STATE OF CALIFORNIA - DEPARTMENT OF TRANSPORTATION — Caltrans

MARK	DATE	DESCRIPTIONS	BY	CH'D	CCO#
		REVISIONS			
3	03/27/13	ADDITIONAL SAS MISCELLANEOUS ELECTRICAL CHANGES	RR RSB	RG	191S2
2	03/01/11	BASE INTEGRATION	RSB	WB	150
1	02/25/08	CABLE TRAY CHANGES	JD	RG SE	42S1

CONTRACT CHANGE ORDER NO._____
SHEET _____ OF _____

SAS SUPERSTRUCTURE AND SKYWAY STRUCTURE
GIRDER INTERFACE WESTBOUND

E-221C

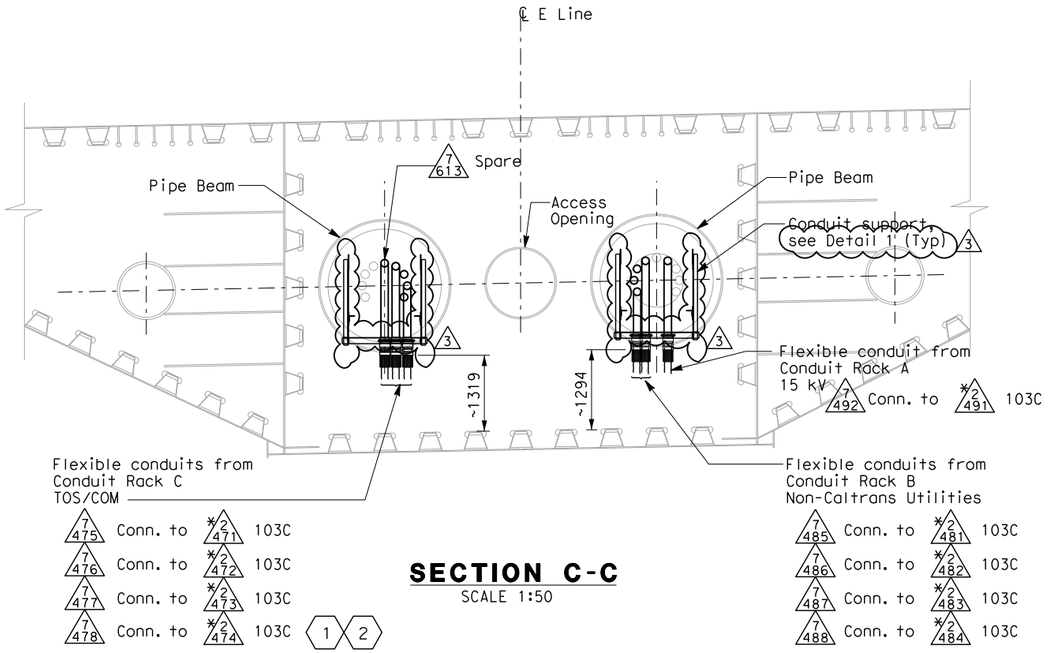
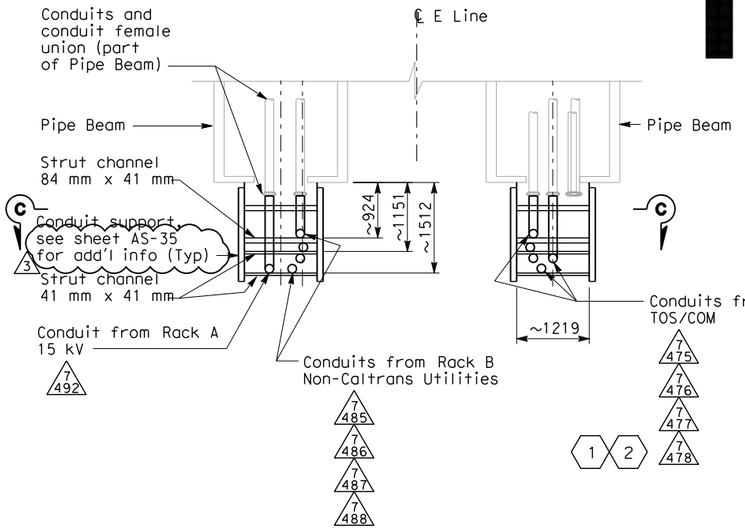
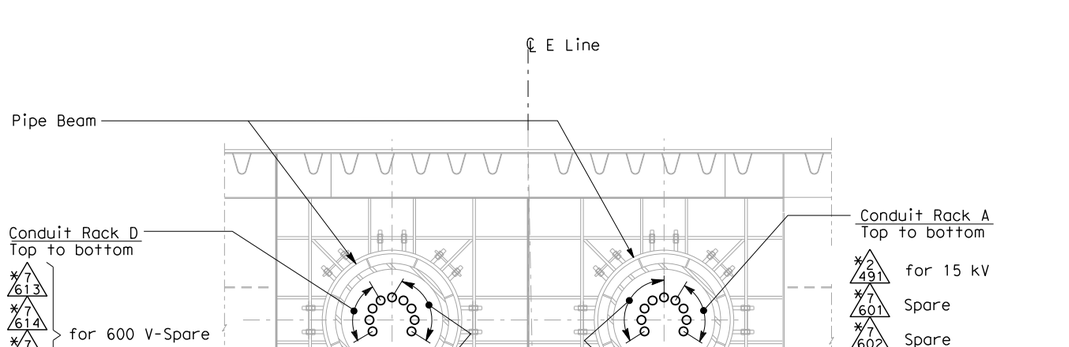
1. Furnish and install 4-25.4 mm innerducts inside TOS/COM conduits (*2474, 7478) and 1-25.4 mm innerduct per BASE fiber optic cable in TOS/COM cable tray.
2. Furnish and install BASE fiber optic cable in innerduct inside TOS/COM conduit and cable tray. See sheet E-1101.

MARK	DATE	DESCRIPTIONS	BY	CH'D	CCO#
		REVISIONS			
3	03/27/13	ADDITIONAL SAS MISCELLANEOUS ELECTRICAL CHANGES	RR RSB	RG	191S2
2	03/01/11	BASE INTEGRATION	RSB	WB	150
1	02/25/08	CABLE TRAY CHANGES	JD	RG SE	42S1

AS-35

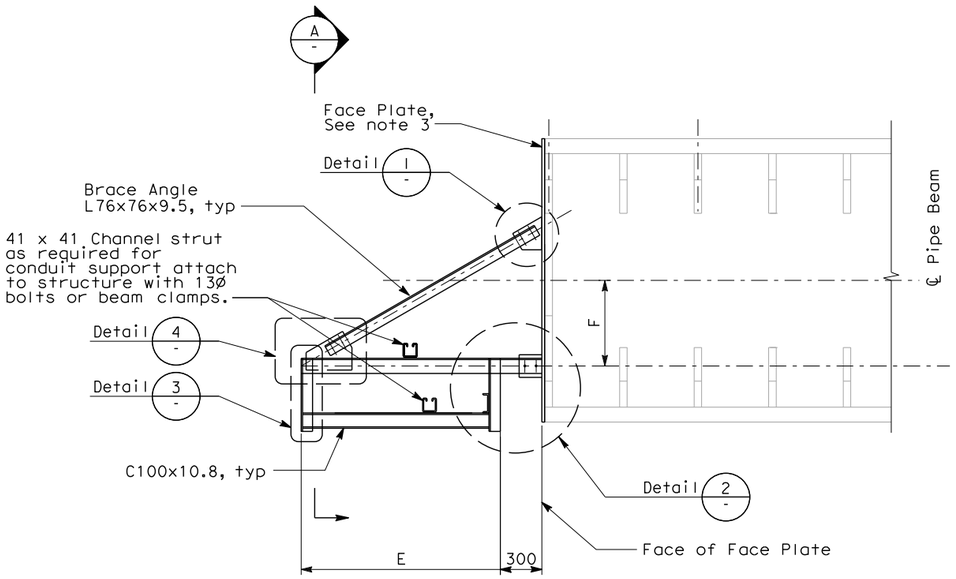
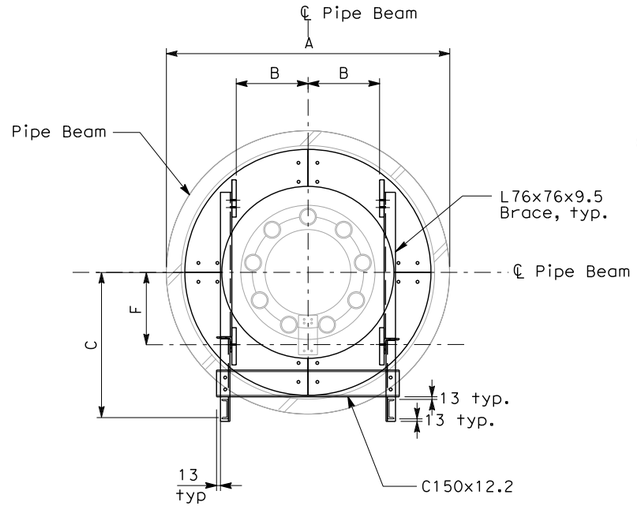
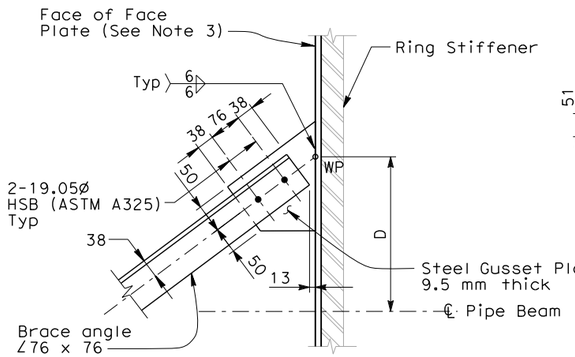
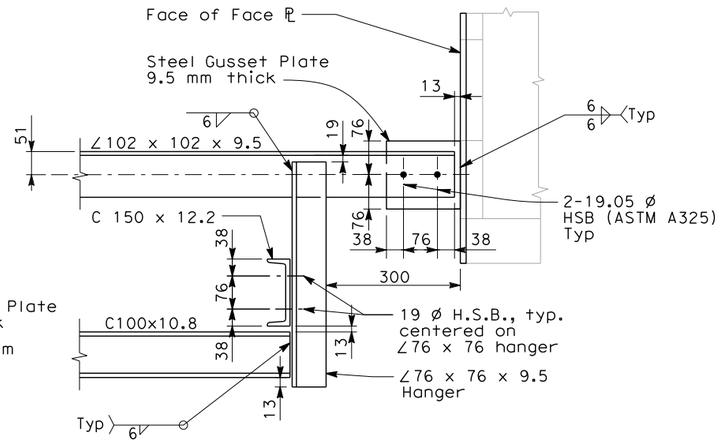
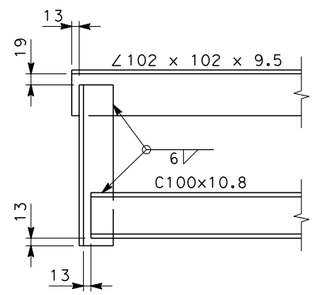
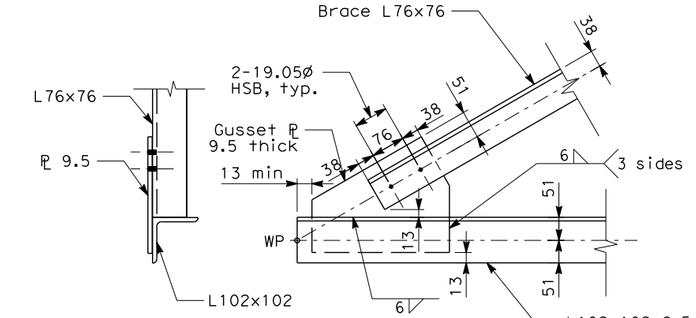
1. For General Structural Notes, see AS-1.
2. For other details not shown, see electrical plans.
3. See sheet AS-35A for face plate.

MARK	DATE	DESCRIPTIONS	BY	CH'D	CCO#
		REVISIONS			
0	03/27/13	ADDITIONAL SAS MISCELLANEOUS ELECTRICAL CHANGES	SAM	RG	191S2

BRIDGE NO.	SAS/SKYWAY SUPERSTRUCTURE
34-0006	
KILOMETER POST	GIRDER CONDUIT/CABLE TRAY SUPPORT DETAIL - SHEET 2 OF 4
13.2/13.9	AS-35A

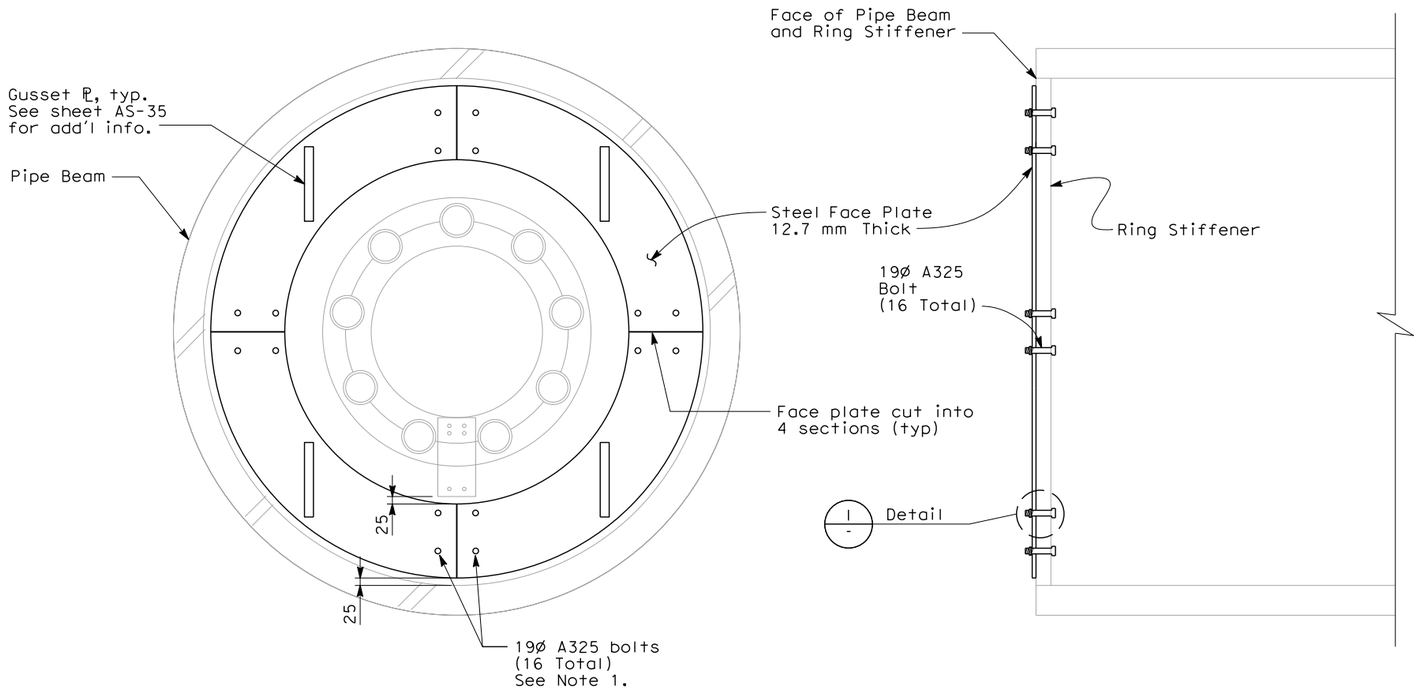
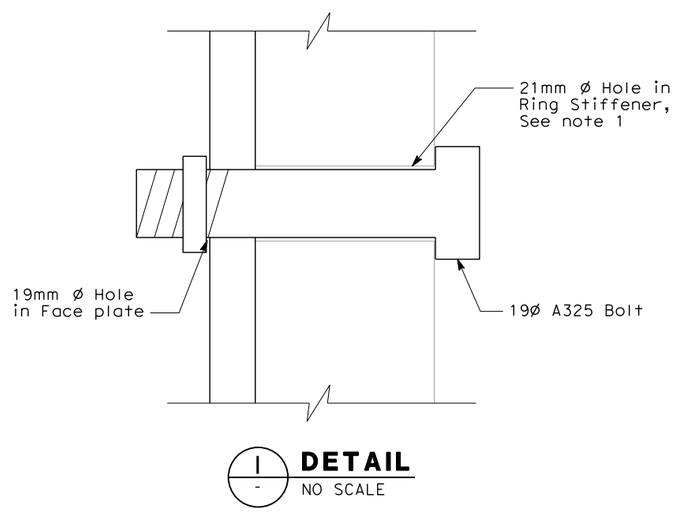
1. Bolt locations in face plate shall match existing bolt pattern in ring stiffener as shown. Verify existing bolt holes sizes in field.
2. Bolts shall be installed with lock washer.
3. All structural steel shall be hot-dipped galvanized.

MARK	DATE	DESCRIPTIONS	BY	CH'D	CCO#
0	03/27/13	ADDITIONAL SAS MISCELLANEOUS ELECTRICAL CHANGES	SAM	RG	191S2
		REVISIONS
